MEMORANDUM

From:	Tina Cuss Ecology Officer		
Service	WBC Ecology	App No:	242953
Address:	The Horns Inn, Crazies Hill, Wargrave, RG10 8LY.		
Proposal:	Full application for the proposed change of use of part of the upper floor to guest accommodation (Use Class C1) and part to flexible Class C1 and E use; erection of a replacement gazebo with PV panels, removal of decking and 2 no. existing sheds and erection of 1 no. shed, plus landscaping and external alterations to the building including changes to fenestration and erection of a single storey canopy roof to the side.		
Type of Development:	Other Change of Use		
Site Visit Made:	No

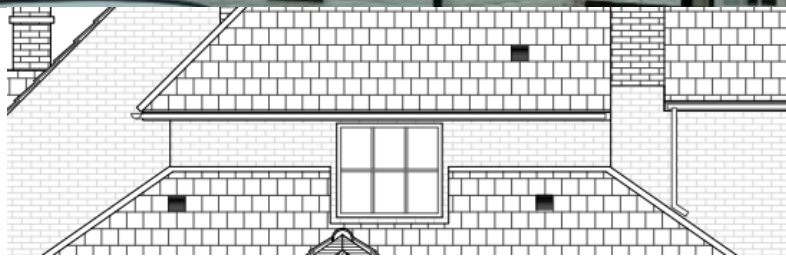
In the absence of further information and mitigation I cannot agree with the Ecologist's conclusion that the need for European Protected Species Licence has been ruled out. Given the apparent water damage to the plaster board of the section of ceiling below Roost 2 I disagree that the roost will not suffer any impacts or modifications during the proposed internal works and consider that it is likely that works will be undertaken which could cause disturbance to the existing ceiling including insulation or repairs and loss of the access gap and potential roosting features. The Preliminary Roost Assessment did not identify the potential roosting features around Roost 2 and Chase Ecological Consultancy have not provided further external inspections to identify where the access to the roost is located. The Ecologist has not considered the impact of the soil stack proposed to be installed in front of Roost 2.

Roost 2 was previously described as being in the lower part of the roof. It is therefore unclear why the Ecologist proposes all fixing must avoid the enclosed void spaces between the vaulted ceiling and tile coverings, as this suggests that the roost is in the void and not crevices adjacent to the access point. According to the Design & Access Statement the en-suites would be entirely protected by overboarding. The top of the en-suites is proposed to be flat, to allow the attic shape to be visible above the en-suite. Further explanation is needed regarding the statement that roof tiles would be used to supply the ventilation and the ecologist's suggestion that roof tiles will be removed for new ventilation over 2.5m from the access point. This is inconsistent with the proposals the ceiling would be vaulted ceiling would be visible, and duct and vents would not be installed above the ensuite flat ceiling.
